From: S.I. & A.K. Lodge [REDACTED]
Sent: Friday, 8 November 2013 1:44 PM
To: DMITRE:MiningRegRehab
Subject: REX Minerals MLP Submission
Attachments: REX Minerals MLP Response Stewart I Lodge.docx; 11337 ADV081113 ER1D.pdf; Kaempf Submission.pdf

REX Minerals MLP Response

Re: Rex Minerals Hillside Copper Mine project – preliminary independent technical review and comment

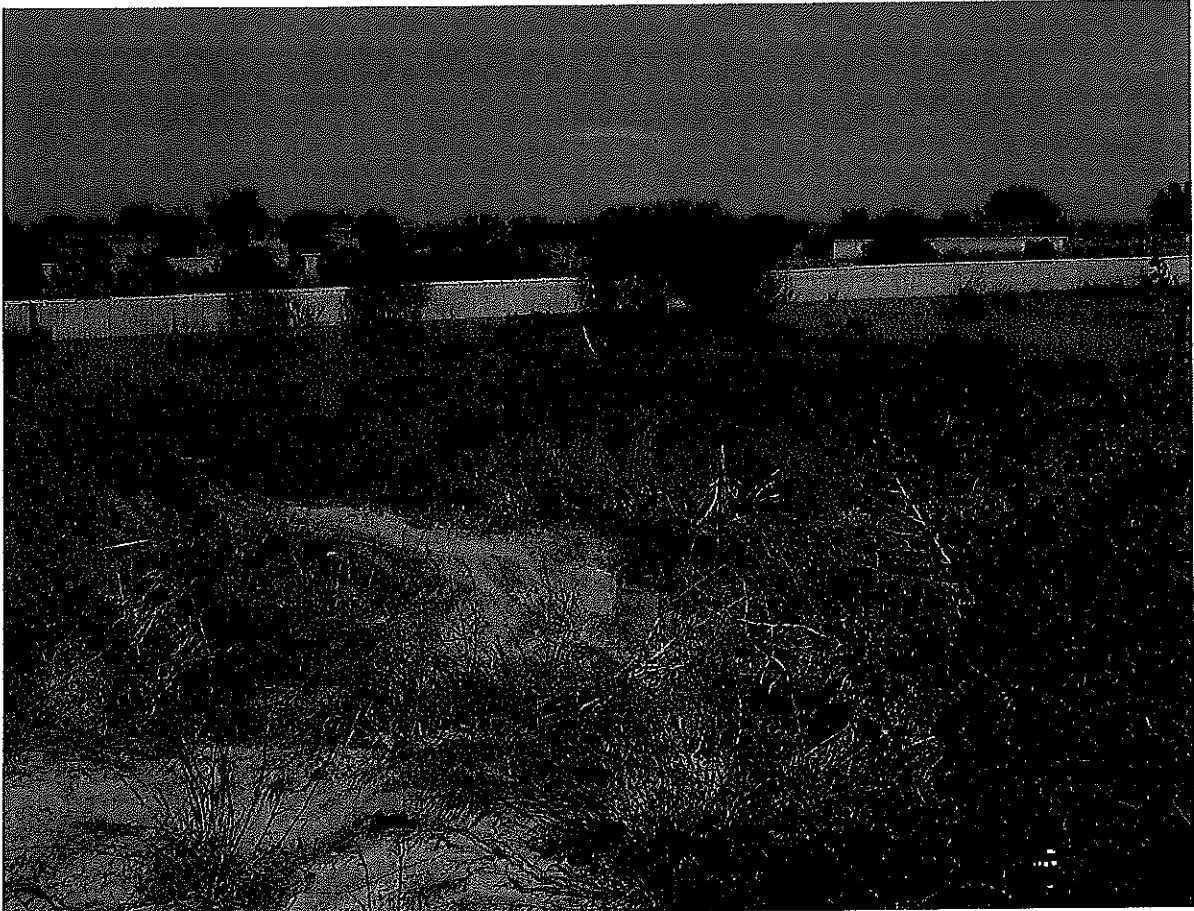
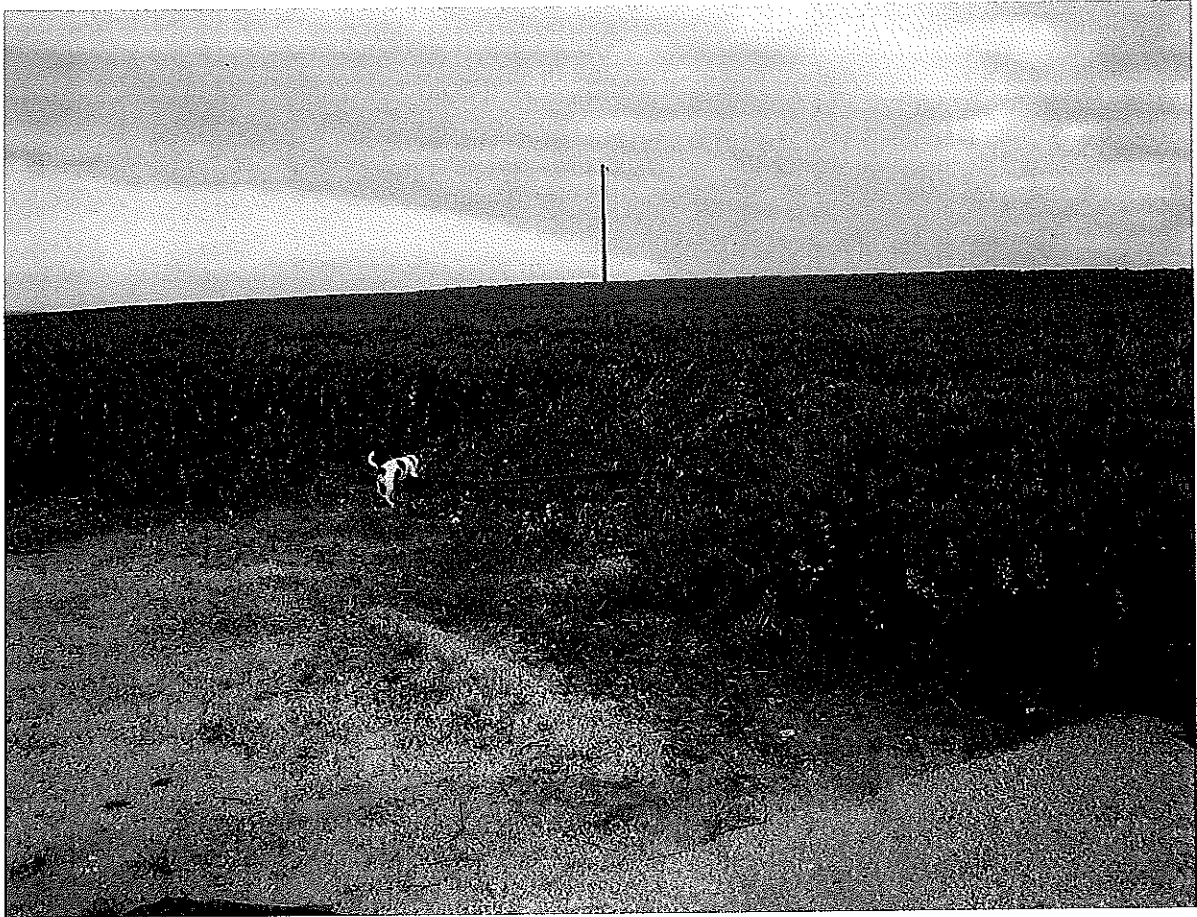
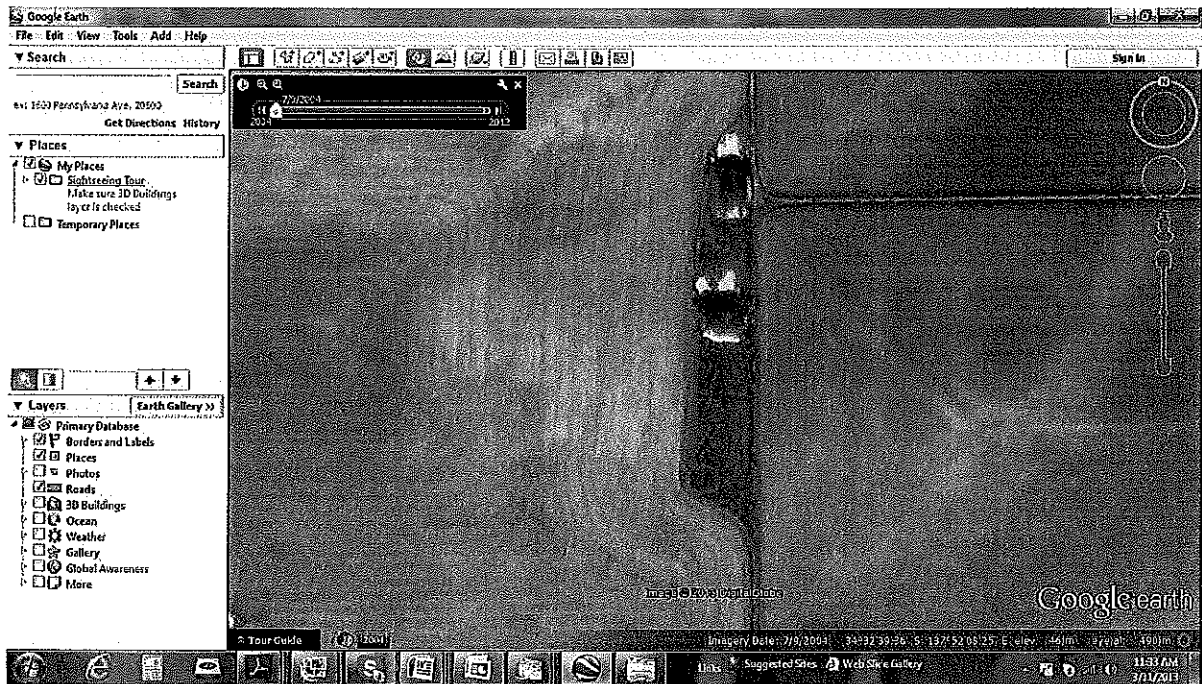
REX's environmental record is nothing short of shoddy. In November 2010 it came to my attention that REX were dumping their drill tailings in an old effluent pond near Ardrossan & near our house. They were using trucks with Minlaton Septic written on the side. As the old ponds are still used for dumping pumped out town septic pits the REX trucks didn't draw any attention until my neighbour noticed the different colour & odour. At the time REX were promoting their uranium deposits to their shareholders. As I was concerned about the minerals in this dump I complained to our local council. They said it was only drill mud & was ok until I explained what might be in it. They did not realize the implications until then & stopped REX immediately. I believe the council had the drill tailings analysed. The first two photos are of the first drill tailings dam. (photo 1 & 2) Immediately following the disallowance of the first dam REX set up more at Hillside in an existing farm dam & also excavated a new dam which was of course in a gully or water course. One they lined with 3 meter wide black plastic strips (a great seal) & the other was just excavated & filled with tailings. See photos. Rainfall following the use of these dams was as follows: December 41.5mm, January 2mm, February 53mm, March 102mm. These are large rains causing water to overflow the already full dams & naturally down the watercourse & into the sea, remembering the toxicity of copper to marine life the health of the gulf was already threatened back then with REX's cost saving measures. (photos 3, 4 & 5) Photo 9 shows the original dams in 2004 & the new dams now. Note that the old dams have been filled over.

Photos 6, 7 & 8 are drilling associated incompetence on my property & complete disregard for the environment. Photo 8 shows a mound of precious top soil which was removed without my knowledge or permission. It was agreed they would not come on after rain & the top soil would not be removed. I was away at the time.

1) REX's first tailings dam only 1.6 km from the town of Ardrossan & 1.3 km from our house. Dec. 2010

2) REX's first drill tailings dam (note the dead trees & brown slurry). Dec. 2010

3) Makeshift drill tailing dams with gully & gulf behind.

4) Hillside Tailings dam

5) Hillside drill tailings dam. Note the gully & gulf in the back ground.

6) A mess in the crop!

7) Bogged & bogged again! I was away when this happened. This section will not grow a crop.

8) Five to ten tonne of topsoil removed from the drill pad. The ground is still affected.

Figure 4: Predicted maximum 24-hour PM₁₀ concentration – including background concentrations with dust emission controls in place. Figure 8.3-2 of the proponent's proposal.

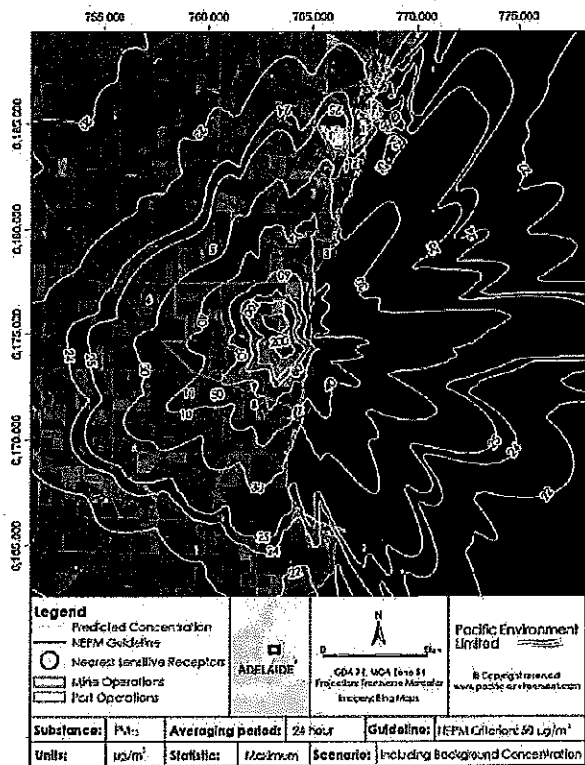
The proponent did not undertake any marine dispersal studies as part of their proposal. For a project of this enormous scale, the use of state-of-the-art hydrodynamic modelling tools should be a standard requirement for the assessment of the effects of the dispersal of dust and potential coastal surface discharges into the marine environment. A clockwise circulation pattern in the gulf, also briefly mentioned in Section 5.11.1 of the proposal, implies a possibly continuous influx of mining-related pollutants into the upper Gulf St. Vincent marine park. The existence of northward flow along the western coast of upper Gulf St. Vincent is confirmed in one of the few oceanographic studies that have been undertaken in the study region (**Figure 2**). The proponent has decided to ignore this flow pattern and its potential detrimental impacts on the marine ecology of the upper Gulf St. Vincent – although there are industry-standard scientific tools that could be and should have been used to address this important point.

The proponent has neither reviewed nor scientifically explored the physical oceanography of Gulf St. Vincent and its upper reaches. The proponent has decided not to simulate the pathway and dispersal of coastal surface runoff events and the sediment contained in it. The proponent has also decided not to scientifically study the pathway and dispersal of mining-related dust deposition in the marine environment. Consequently, the proponent's claims in the impact assessment that both factors (ML-A7, ML-SW1,2,3,4) are of minor consequences cannot be scientifically tested and are pure speculations being void of any credible scientific evidence. Hence, the assessment of marine-related consequences presented as part of the proposal does not meet the required scientific standards and should be rejected. Indeed, due to the close vicinity of mining activities, the marine environment must be declared one of the "nearest sensitive receptors". Figure 8.3-2 of the proposal (reproduced here as **Figure 4**) demonstrates the proponents ignorance of the marine environment.
